E4

PLINTH BEAMS

27/12/19
E5
PLINTH BEAMS

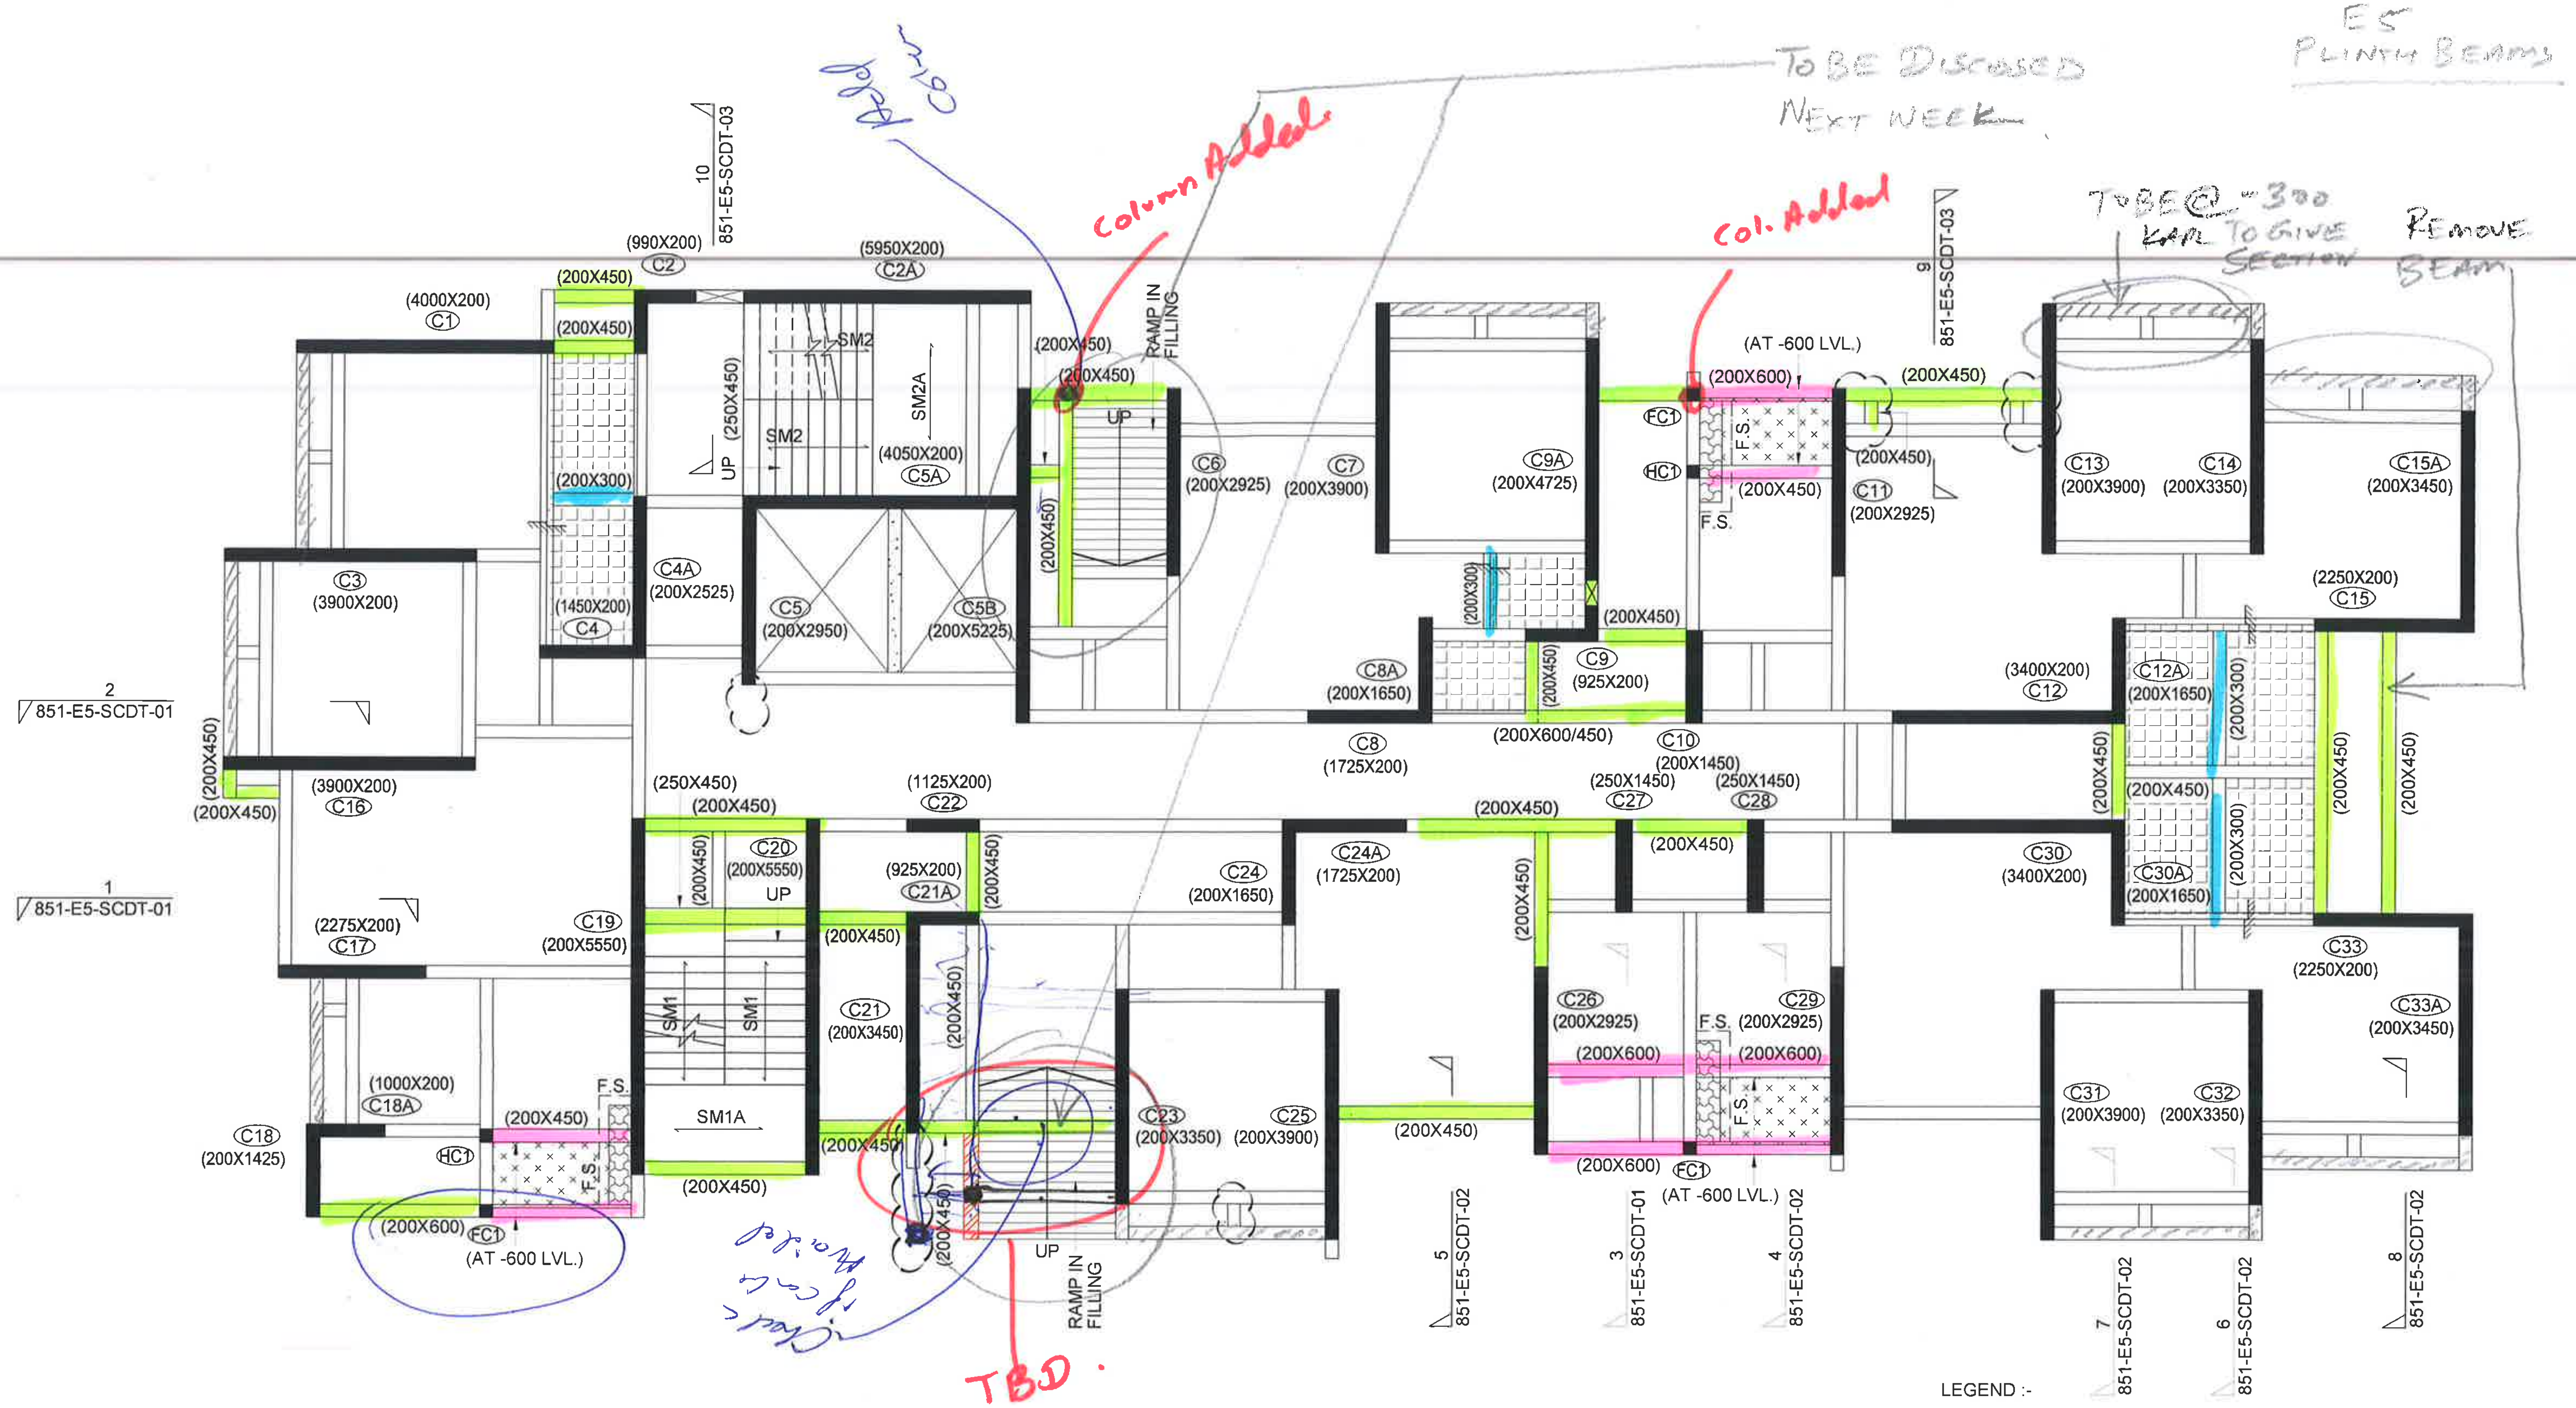
Remove

Only for End Bldg

Remove

Cutout of 200x300 in C34 & C55A 450 DEPTH SUBJECT TO CHECK

TO BE DISCUSSED NEXT WEEK

RAMP IN FILLING UP

LEVEL ?

UPDATE IN ARCH PLAN

RAMP IN FILLING

MEP To Give ground Coordy

ADD COLUMN

CHECK WITH DESIGN

REMOVE

BEAM TO BE @ -300. KAPE TO INDICATE IN THE ARCH SECTIONS.

SLEEVE @ 65ϕ

Cutout 200x300 ϕ

Column Added

Column Added
